BMP NUMBER: **CC019**

Project Name: Kingsmill Pond Spillway Repair
County Plan No.: E&S 022-15
Stormwater Management Facility: Wet Pond
BMP Phase #: ☐ I ☐ II ☐ III ☐ IV (These are County assigned phasing/colors on GIS map.)

Project Name: Spillway Retrofit and Repair - Kingsmill Pond
Structure/BMP Name: Kingsmill Pond Dam
Project Location: 144-198 Macaulay Rd. Williamsburg, Virginia 23185
BMP Location: 144-198 Macaulay Rd. Williamsburg, Virginia 23185
County Plan No.: E&S-022-15 VAHU6 HUC Code: JL34

Reference: **Spillway Retrofit and Repair – Kingsmill Pond (E&S-022-15) Record Drawing and Construction Certification Forms.**

SITE ACCESS MAP

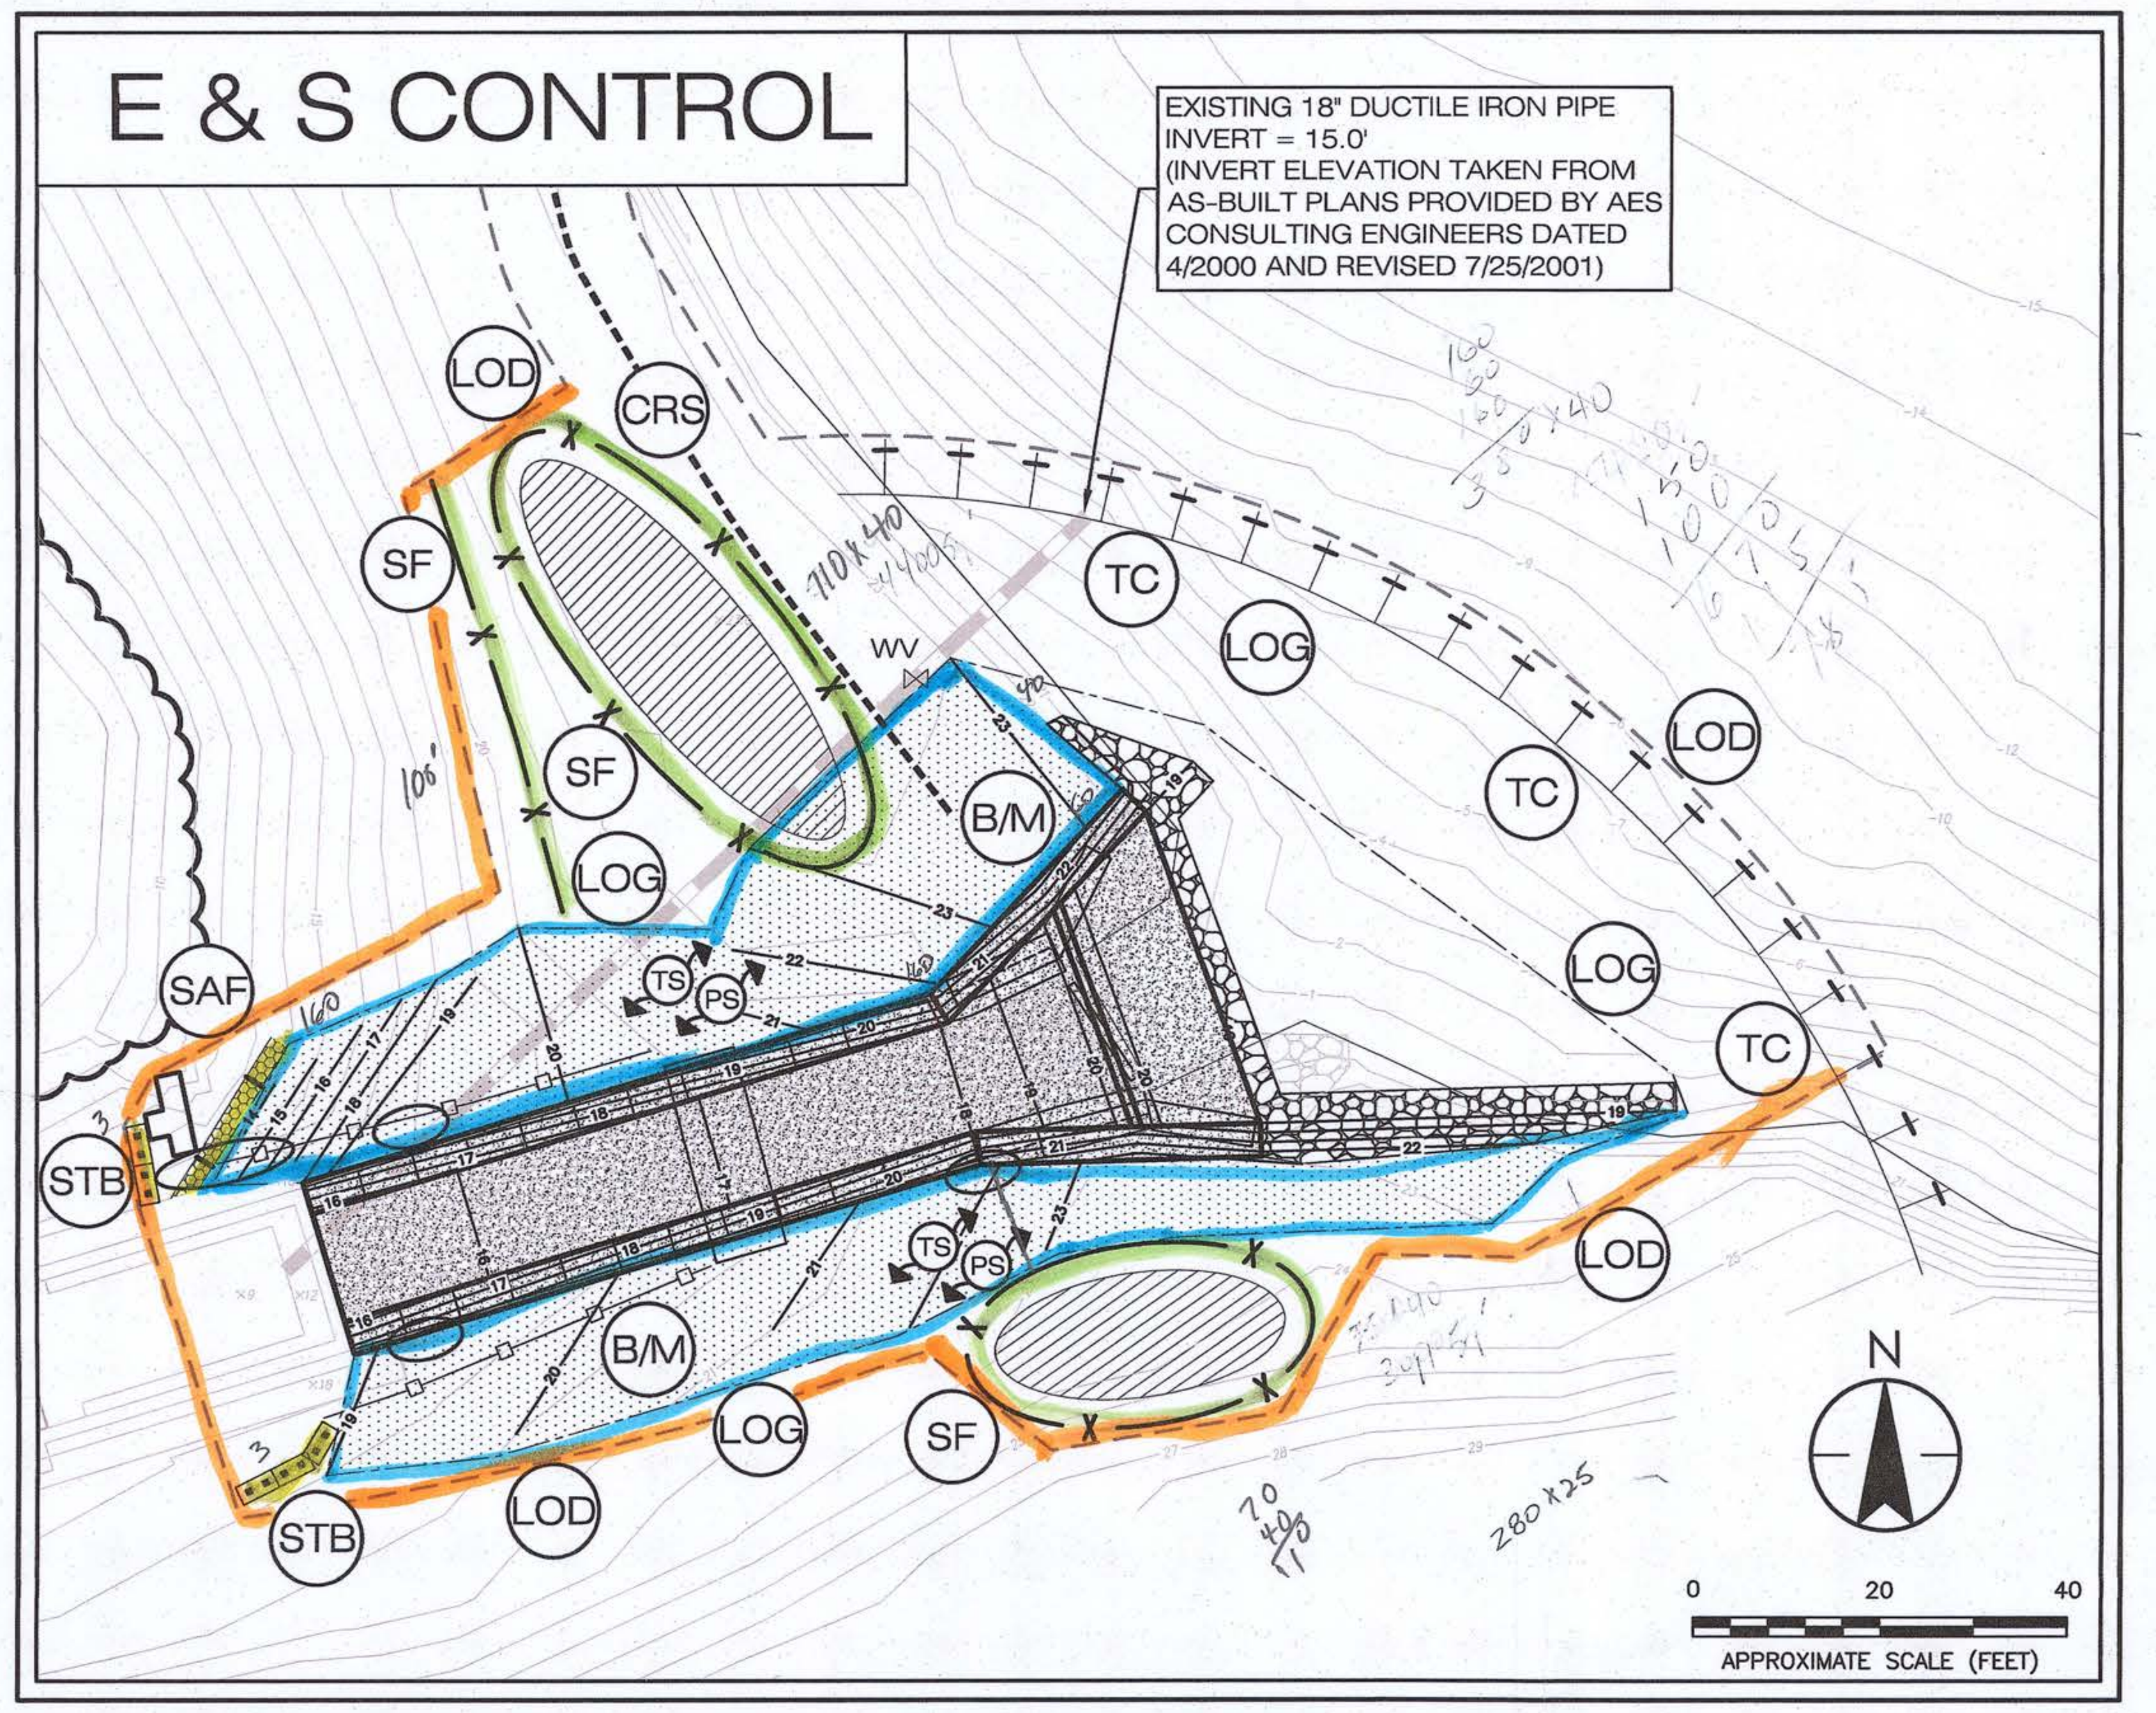
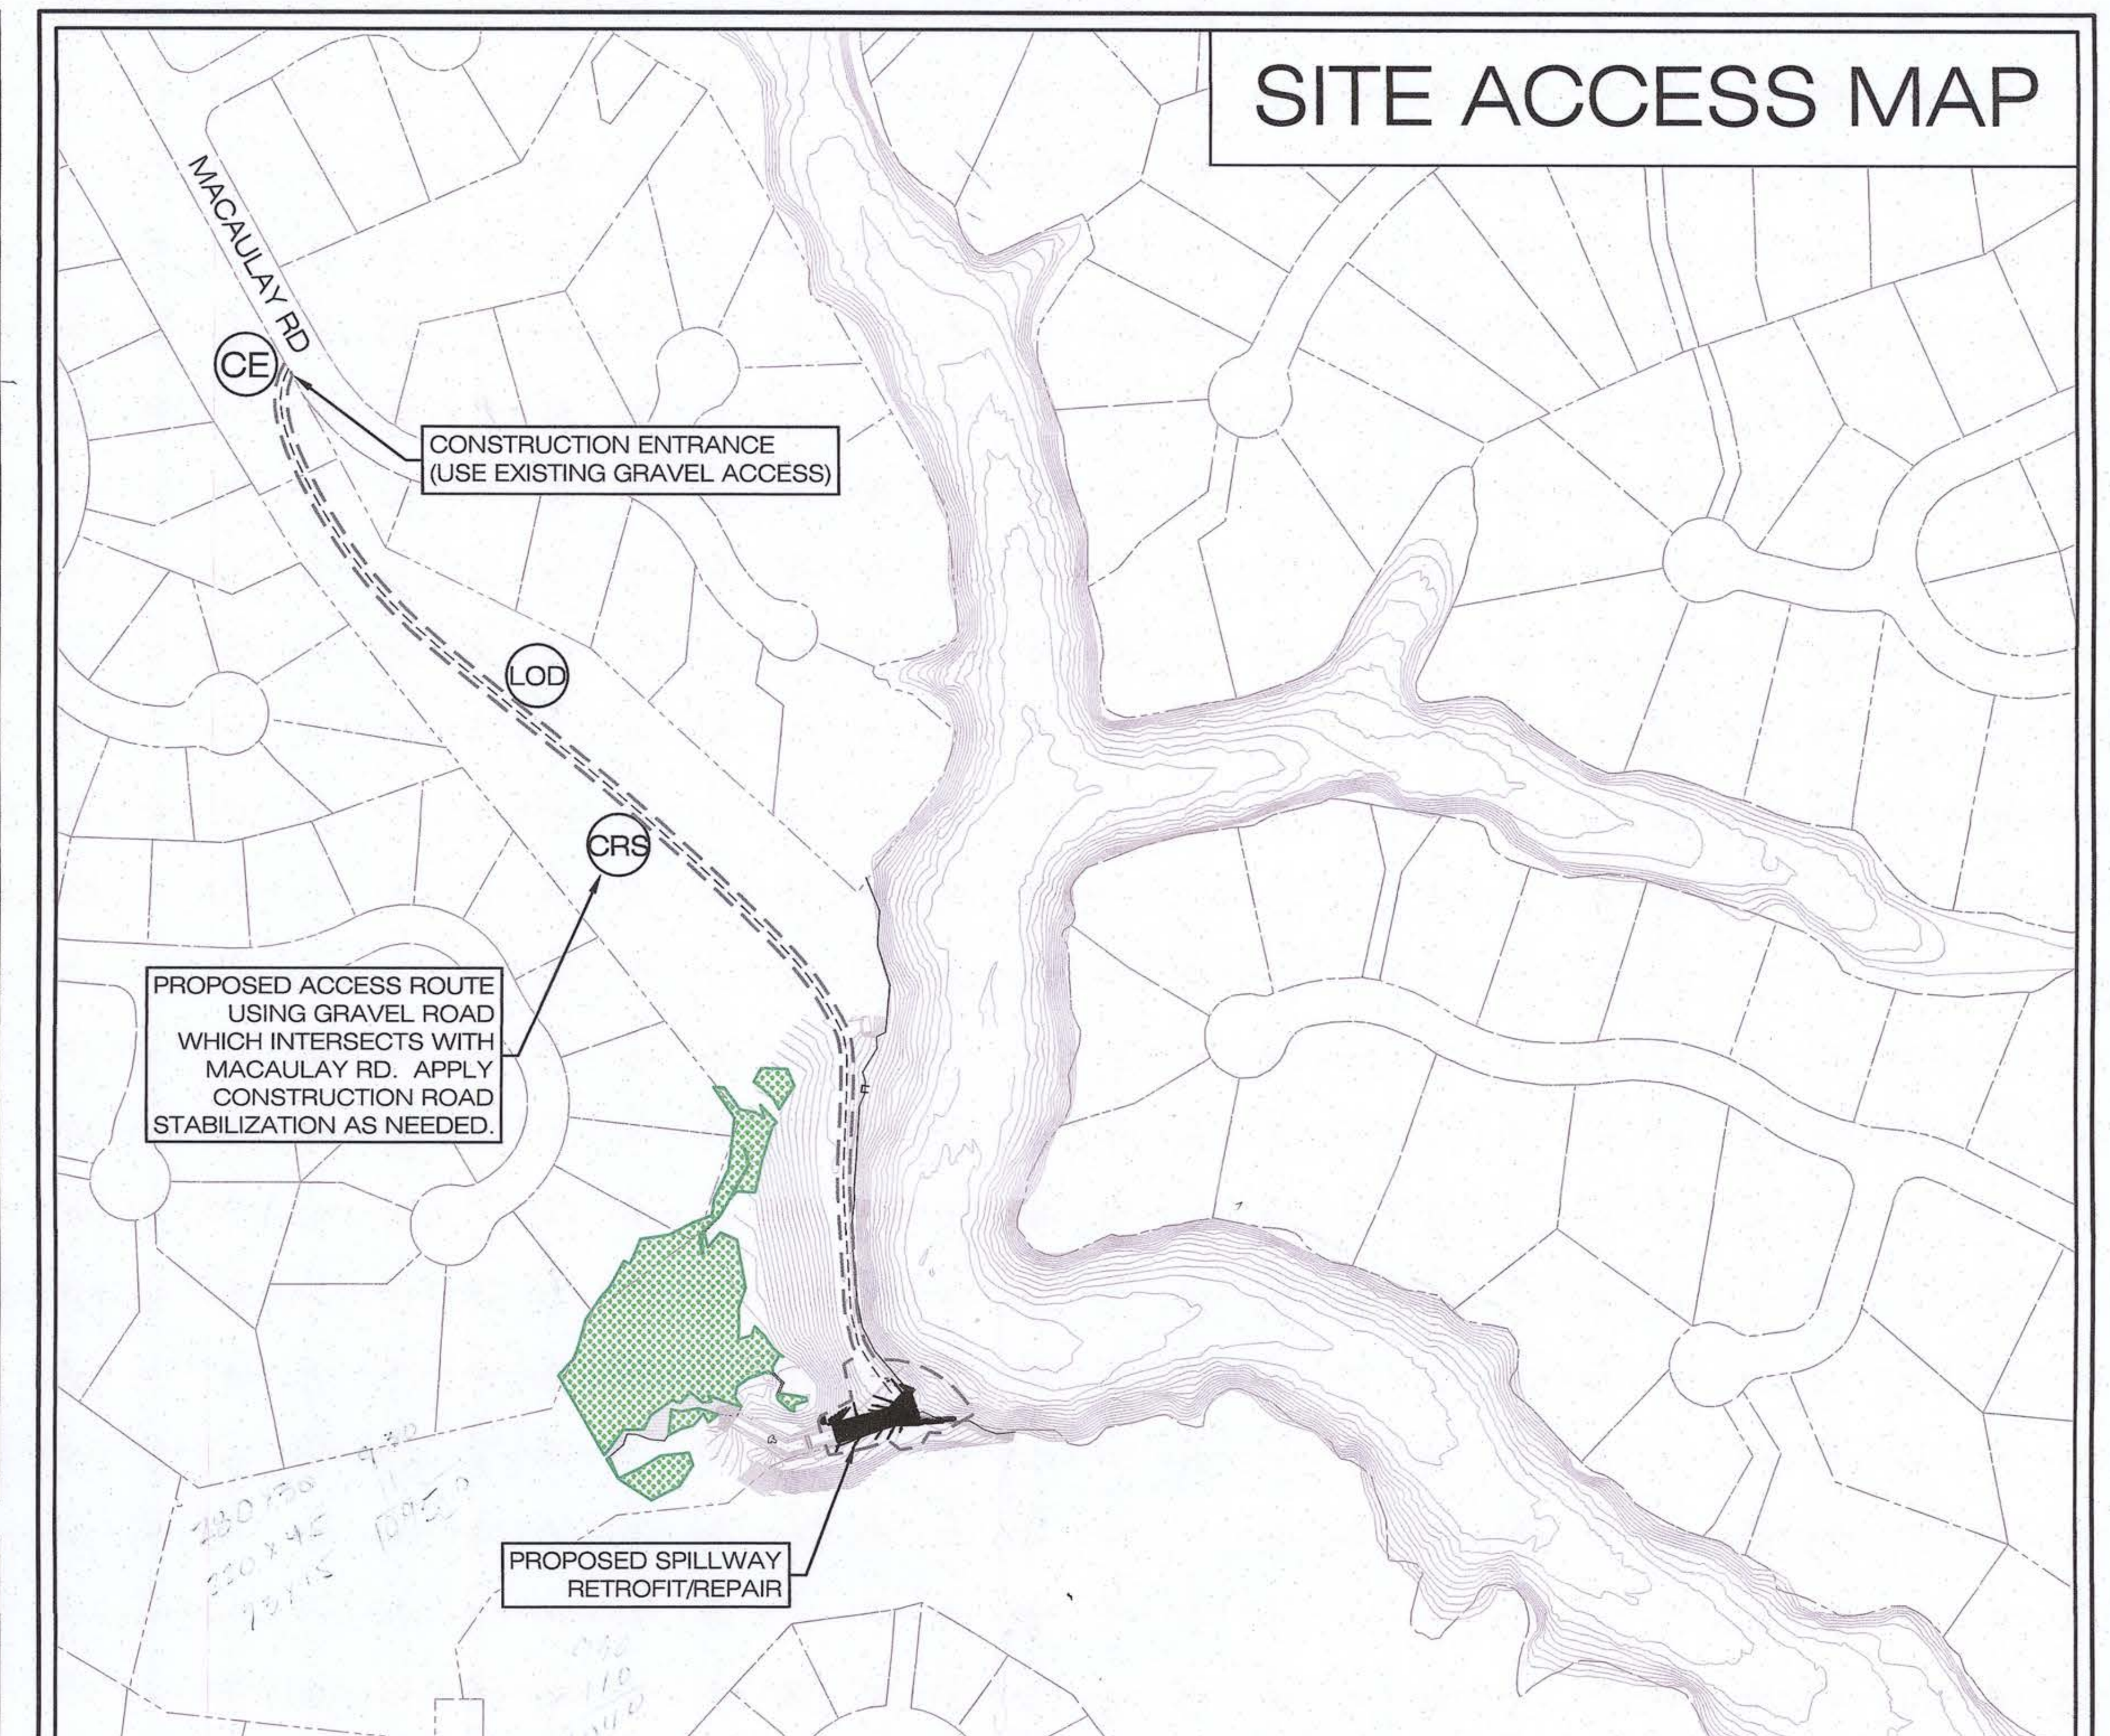
10. Standard Notes. Replace erosion control notes provided on Sheet 4 of 9 and replace with James City County Engineering and Resource Protection Division standard Stormwater Pollution Prevention Plan Notes dated July 1, 2014. These are available on the ERP website and have been the standard notes for all plans since July 1, 2014.

16. Erosion and Sediment Control Notes, Sheet 4 of 9.

17. Sequence of Construction. The following adjustments should be made to the sequence found on Sheet 5 of 9:

A reference to notification of Miss Utility is included in the E&S notes on Sheet 5. See Note #16 (re-numbered to #17).

Temporary stockpile areas are shown on the E&S plan on Sheet 5. We have added labels for clarification.

No offsite land disturbing areas outside of otherwise approved borrow, waste, or disposal sites are anticipated. We have added a corresponding note on Sheet 5 in the Sequence of Construction.

Site access is shown in its entirety on the "Site Access Map" on Sheet 5. We have rescaled this access map for clarity and added the limits of disturbance.

We have added a corresponding note on Sheet 5 as Note 1.
